**Amendments to the Drawings:**

**REMARKS/ARGUMENTS**

This communication is responsive to Office Action of July 27, 2004 in which the following objections were raised: [1-2] The abstract of the disclosure was objected to because it exceeded 150 words; [3] The drawings were objected to under 37 CFR 1.83(a). The drawings must show every feature of the invention specified in the claims. [4] The drawings were objected to under 37 CFR 1.83(p)(5) because they did not include the reference character(s) mentioned in the description. [5] Claims 1-16 were rejected under 35 U.S.C. 112, first paragraph, as failing to comply with the enablement requirement; [6] Claim 6 was rejected under 35 U.S.C. 112, second paragraph, as being indefinite for failing to particularly point out and distinctly claim the subject matter; [7] Claims 1, 7 and 9-12 were rejected under 35 U.S.C. 103(a) as being unpatentable over Vareljian; [8] Claims 2-4 and 13-15 were rejected under 35 U.S.C. 103(a) as being unpatentable over Vareljian in view of Langberg et al.; [9] Claim 6 was rejected under 35 U.S.C. 103(a) as being unpatentable over Vareljian in view of Mannerma.

FIG. 5A

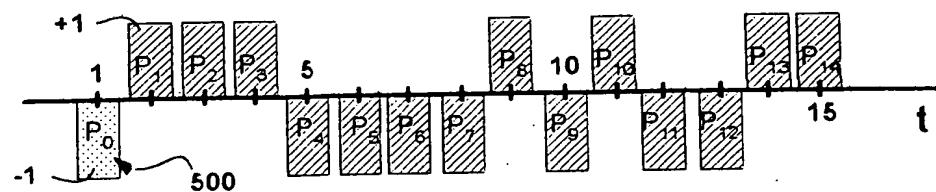
Applicant's has noted the omission in the specification of the reference numbers 500, 502 and 504 shown in FIGS. 5A, 5B, 5C respectively, which correspond with the start of the PRN sequence shown in FIG. 5A, the start of the leakage signal shown in FIG. 5B and the start of the first reflection signal in FIG. 5C respectively. The PRN sequence shown in FIG. 5A is clearly shown in both the leakage and reflected signals shown in FIGS. 5B and 5C respectively. The dotted pattern, as opposed to the cross-hatch, marks the start of the PRN

signal 500 in FIG. 5A as well as the start of the reflections thereof 502, 504 shown in FIGS. 5B and 5C in the same dotted pattern.

FIG. 5E

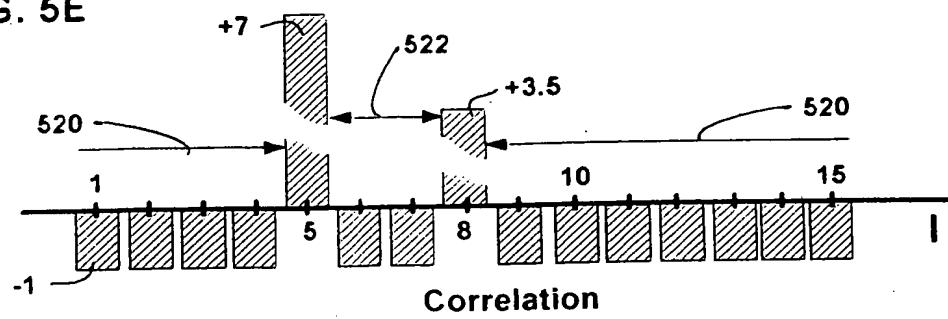
The drawings were objected to under 37 CFR 1.83(p)(5) because they did not include the reference character(s) 530 and 532 mentioned in the description.

Reference characters 530 and 532 have been added to FIG. 5E to correspond with the specification, where they are identified as the leakage peak and the peak corresponding with the first reflected signal, respectively. “*FIG. 5E shows the correlation factors for the received signal. Two peaks in the ordered set of coefficients are shown, peak 530 and peak 532. Depending on the initial sampling of the composite received signal these could occur in the order shown or could be shifted across/around the correlation graph. In the example shown the leakage peak 530 follows the interval of greatest separation between peaks, i.e. interval 520. This corresponds with the tail of the reflections from the furthest end of the subscriber line in which any reflections are most severely attenuated. The leakage peak is separated by interval 522 from the first correlation coefficient peak 532 which peak corresponds with the first reflected signal from the first discontinuity on the corresponding*
